Comments about Parts 9, 10 and 11: Closure, Post-Closure and Corrective Action

**Robert H. Gilkeson, Registered Geologist
Concerned Citizens for Nuclear Safety
Embudo Valley Environmental Monitoring Group**

Re: Public Comments about July 6, 2009 revised draft Hazardous Waste Permit for
Facility: Los Alamos National Laboratory (LANL)
Facility Owner and Co-Operator: U.S. Department of Energy (DOE)
Facility Co-Operator: Los Alamos National Security, LLC (LANS)
EPA ID No.: NM0899910515
Request for Hearing

Concerned Citizens for Nuclear Safety (CCNS) and the Embudo Valley Environmental Monitoring Group (EVEMG) make the following public comments about the July 6, 2009 revised draft Hazardous Waste Permit for Los Alamos National Laboratory (LANL).

Figure 1. Map showing the locations for regional aquifer wells R-42, R-28 and R-15 in Mortandad Canyon.

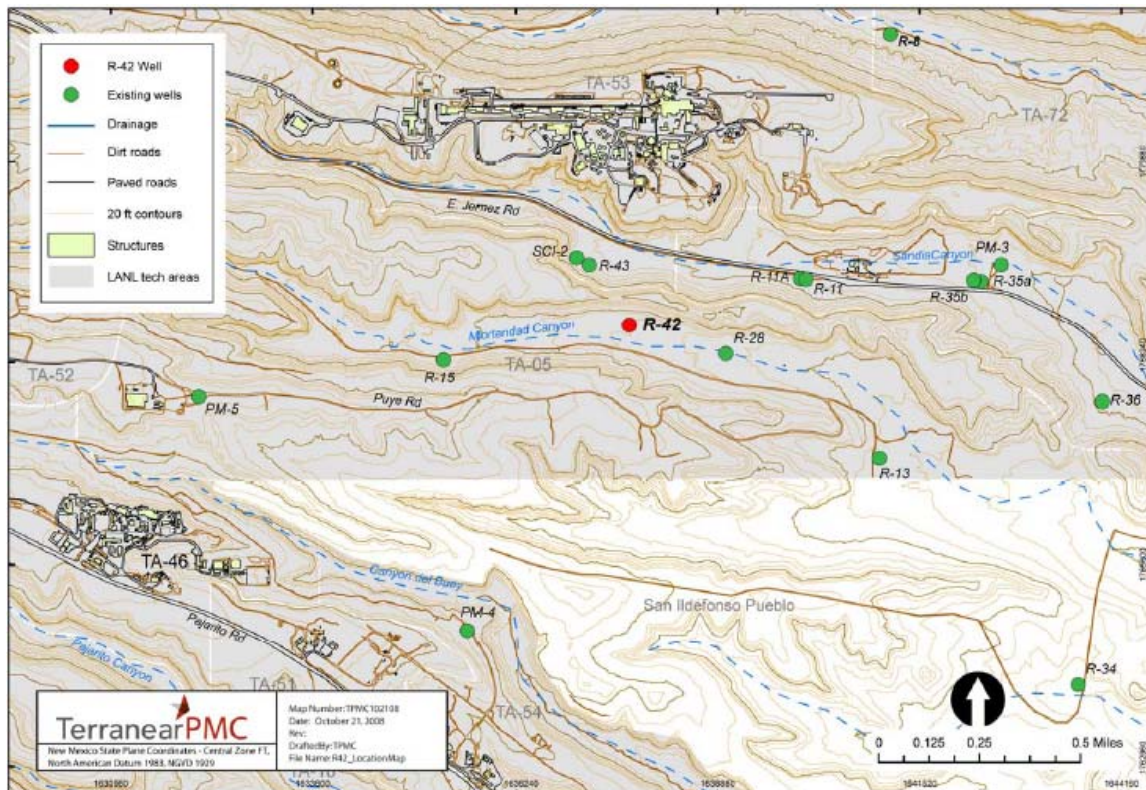
A contaminant plume of hexavalent chromium at levels far above the EPA and NMED water quality standards is present in the regional aquifer over an unknown region below Mortandad Canyon and the adjacent Mesas. The highest known hexavalent contamination is measured in groundwater samples collected from regional aquifer monitoring wells R-28 and R-42. The locations of the two wells are displayed on Figure 1.

Figure 2. Map showing the location for perched aquifer well MCOBT-4.4 in Mortandad Canyon. Well MCOBT-4.4 is located approximately

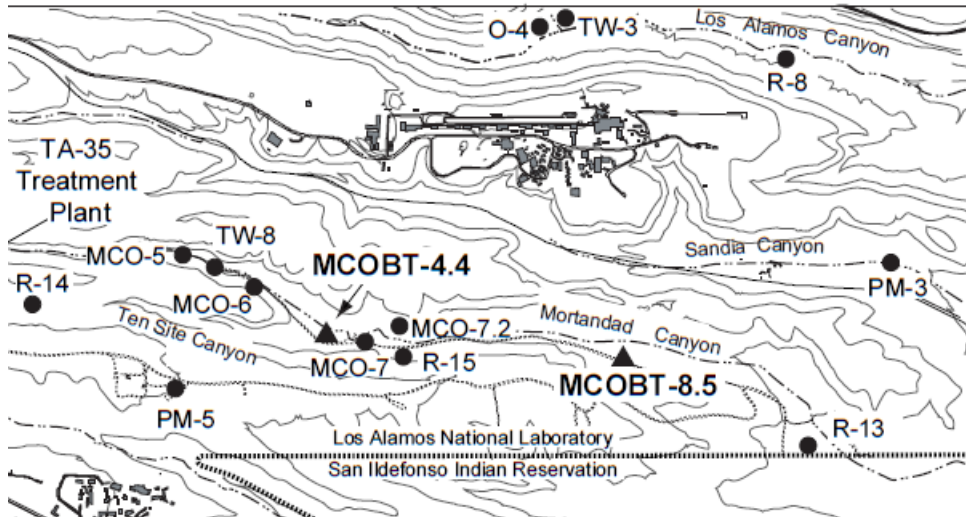
High levels of perchlorate and nitrate are measured in a perched zone of saturation in Mortandad Canyon for water samples collected from LANL monitoring well MCOBT-4.4. A mistake in well installation allowed the contaminated water in the perched zone of saturation to leak downward toward the regional aquifer. Well MCOBT-4.4 is still a pathway for leakage. NMED issued a penalty of \$1.87 million but the well still has not been plugged and abandoned. The location of well MCOBT-4.4 is displayed on Figure 2. (check on action to P&A this well)
